SUBDIVISION REVIEW SHEET**CASE NO.:** C8-2016-0049.0A**P.C. DATE:** 09-27-16**SUBDIVISION NAME:** Broadacres, Lot 17, Blk 6 Resubdivision**AREA:** 0.334**LOT(S):** 2**OWNER/APPLICANT:** David Whitworth Development Company (David Whitworth)**AGENT:** David Whitworth Development Company (David Whitworth)**ADDRESS OF SUBDIVISION:** 5503 JEFF DAVIS AVE**GRIDS:** MJ27**COUNTY:** Travis**WATERSHED:** Shoal Creek**JURISDICTION:** Full Purpose**EXISTING ZONING:** SF-3-NP**NEIGHBORHOOD PLAN:** Brentwood**DISTRICT:** 7**PROPOSED LAND USE:** single family residential**ADMINISTRATIVE WAIVERS:** None

RESUBDIVISION OF LOT 17, BLOCK 6 BROADACRES SUBDIVISION-DWDC

SUBJECT: C8-2016-0049.0A Resubdivision of Lot 17, Block 6, Broadacres
Subdivision Flag Lot variance request

**Variance Backup-
Compatible with
surrounding
neighborhood. Five
other Flag Lots nearby
upon a quick and non all
inclusive count of the
immediate area.**

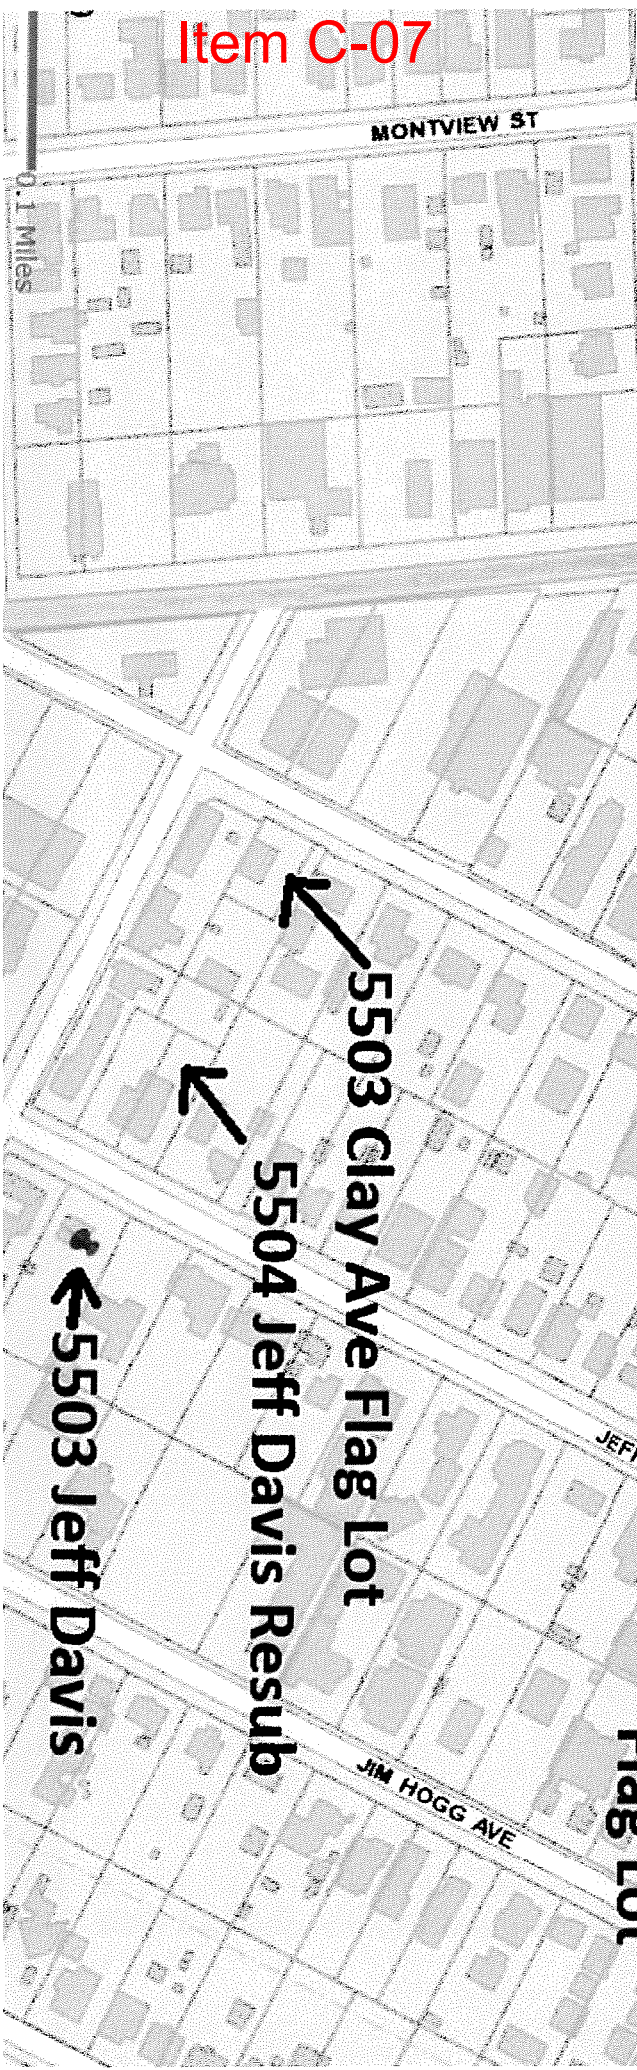
There are already numerous flag lot developments in the immediate vicinity. The entire area is zoned SF-3-NP which is the appropriate zoning for the proposed use. See attached, Surrounding Neighborhood Exhibit which generally shows the development pattern in the immediate vicinity. .
